### DART SERVICE INSTRUCTION

TO AMEND INSTALLATION INSTRUCTIONS IIN-D130-701 REV. F AND INSTRUCTIONS FOR CONTINUED AIRWORTHINESS ICA-D130-701 REV. 4 OR LATER APPROVED REVISION

REF. TCCA STC: SH94-14 REF. FAA STC: SR00213NY REF. EASA STC: 10016996 REF. ANAC STC: 2007S03-03

FIGURE 4A: HOLE PATTERN, INBOARD (FOR EC130 B4) (LH SHOWN, RH OPPOSITE)

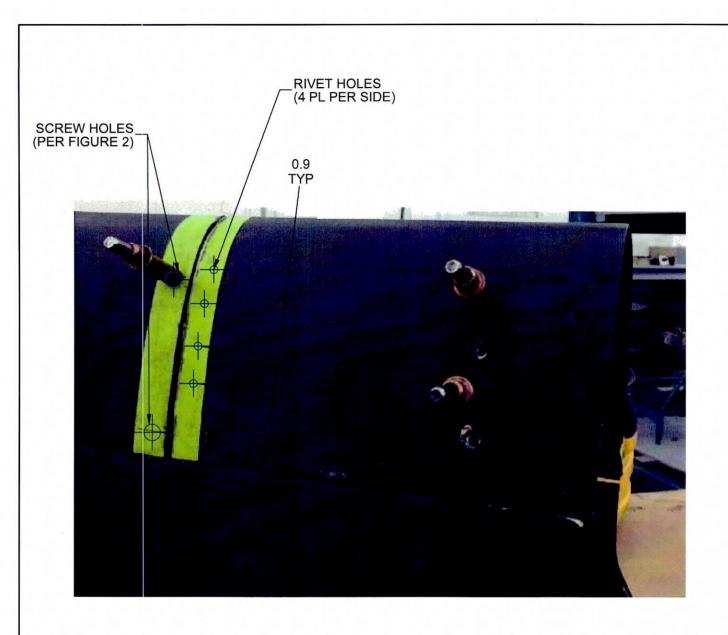
- 2.1.3. Mark dimensions per Figure 1 and Figure 2. Mark the hole pattern per Figure 3A/B and Figure 4A/B.
- 2.1.4. Pitch one Ø0.196 hole in line with the existing screw holes while maintaining edge distance and with the marked dimension per Figure 2. This will help ensure consistant alignment.

# FIGURE 5: FAIRING CUT (LH SHOWN, RH OPPOSITE)

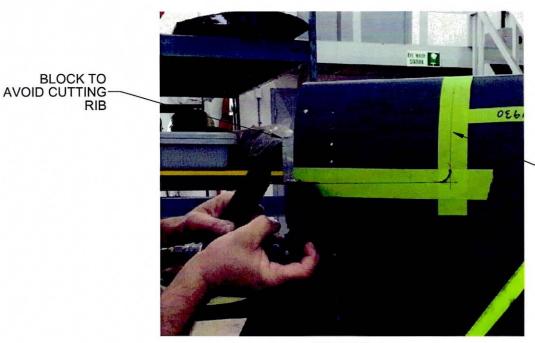
- 2.1.5. Cut along marked line and break any sharp edges. Place a barrier between the Fairing Cover and any existing structure including the rib and the attached composite panel per Figure 5.

# FIGURE 6: D5391-1 PLACEMENT (LH SHOWN, RH OPPOSITE)

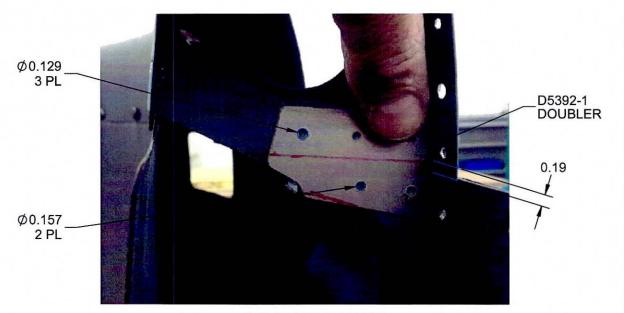
- 2.1.6. Hand form the D5391-1 Strap to fit the curvature of the fairing and clamp in place per Figure 6.
- 2.1.7. Enlarge the remaining previously marked bolt holes to  $\phi$ 0.129 through both the fairing and the D5391-1 Strap and cleco.

FIGURE 8: RIB CUT (LH SHOWN, RH OPPOSITE)

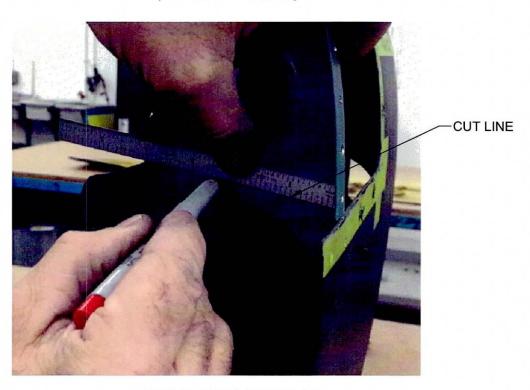
- 2.1.12. For EC130 B4, mark the rib as shown in Figure 8. Clamp the D5392-1 Doubler as shown and transfer drill 3X Ø0.129 and 2X Ø0.157 holes. Cut rib along line shown and break sharp edges.

# FIGURE 9: LN29677M4 ANCHOR NUTS (FOR EC130 B4) (LH SHOWN, RH OPPOSITE)

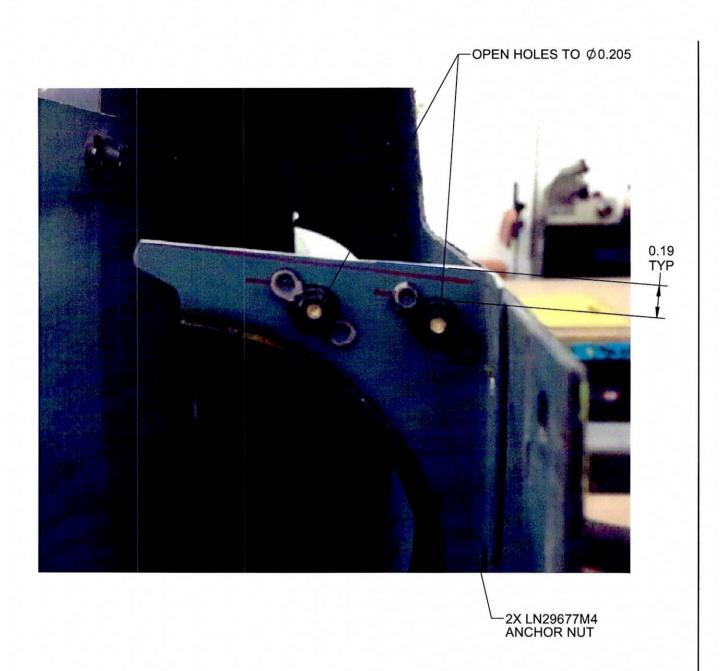
- 2.1.13. For EC130 B4, transfer drill the hole pattern for qty(2) LN29677M4 Anchor nuts on the rib as shown in Figure 9 ensuring 0.19" edge distance. Install qty(2) LN29677M4 anchor nuts using qty(4) NAS1097AD3-3 rivets on the reverse side of the rib.

## FIGURE 10: D5391-1 STRAP INSTALLATION (LH SHOWN, RH OPPOSITE)

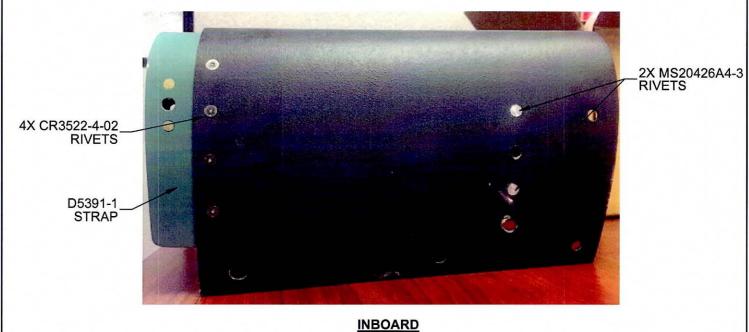
- 2.1.15. Remove the D5391-1 Strap and the D5392-1 Doubler. Prime and paint per Aircraft Maintenance Manual.
- 2.1.16. Install the D5391-1 Strap to the cutout piece with qty(15) CR3522-4-02 Rivets per Figure 10. Plug the rib holes in the cutout piece as indicated in Figure 10 with qty(5) MS20426A4-3 Rivets.

# FIGURE 11: ANCHOR NUT INSTALLATION (LH SHOWN, RH OPPOSITE)

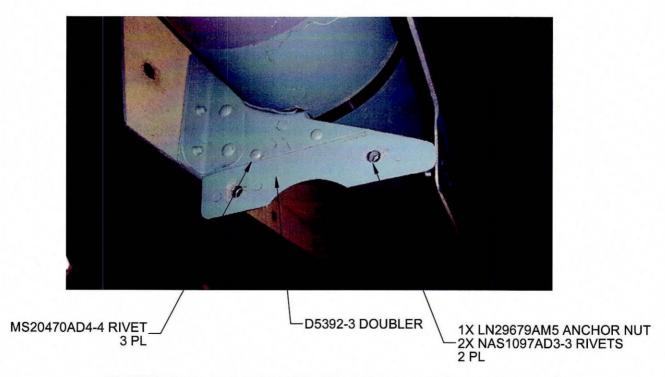
- 2.1.17. Install qty(5) LN29679AM5 anchor nuts using qty(10) MS20426AD3-3 rivets on the D5391-1 Strap per Figure 11.
- 2.1.18. Install qty(4) LN29679AM5 anchor nuts using qty(8) NAS1097AD3-3 Rivets to the rib cutout per Figure 12A (for EC130 B4). Install qty(3) MS20470AD4-4 Rivets to attach the D5392-1 Doubler to the rib cutout per Figure 12A (for EC130 B4).

## FIGURE 14A: RIB CUTOUT INSTALLATION (FOR EC130 B4) (LH SHOWN, RH OPPOSITE)

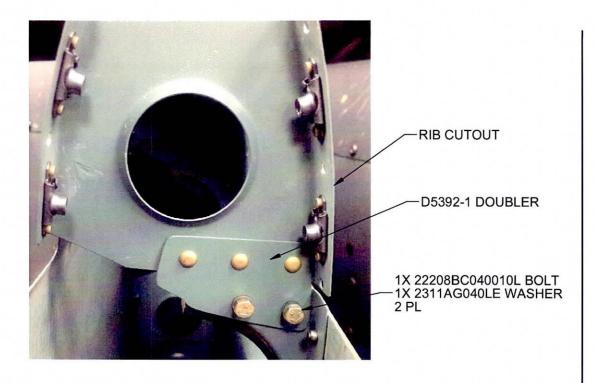
- 2.1.20. Install qty(1) LN29679AM5 anchor nut using qty(2) MS20426AD3-3 rivets on the composite panel per Figure 13.
- 2.1.21. Install the rib cutout to the rib with qty(2) 22208BC040010L bolts and qty(2) 23111AG040LE washers per Figure 14A (for EC130 B4).

## FIGURE 14B: RIB CUTOUT INSTALLATION (FOR EC130 T2) (LH SHOWN, RH OPPOSITE)

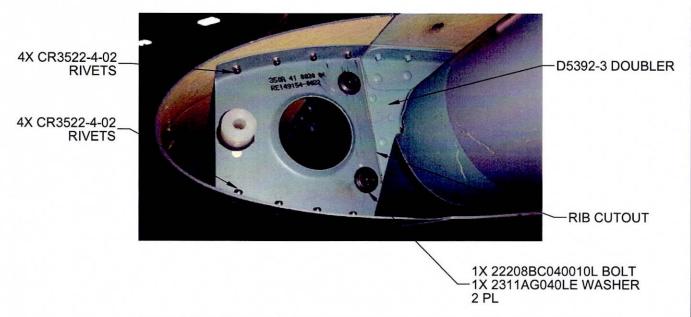
- 2.1.22. Install the rib cutout to the rib using qty(8) CR3522-4-02 Rivets on the composite panel. Install the rib cutout to D5392-3 Doubler with qty(2) 22208BC040010L bolts and qty(2) 23111AG040LE washers per Figure 14B (for EC130 T2).

# FIGURE 15: FAIRING ASSEMBLY (RH SHOWN, LH OPPOSITE)

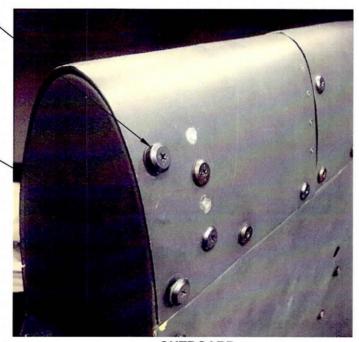
- 2.1.23. Install the fairing cutout and the cap to the fairing with qty(16) A0164TK050S012X bolts (qty(7) from previously retained) and qty(16) 350A21-1218-20 washers (qty(7) from previously retained) per Figure 15.
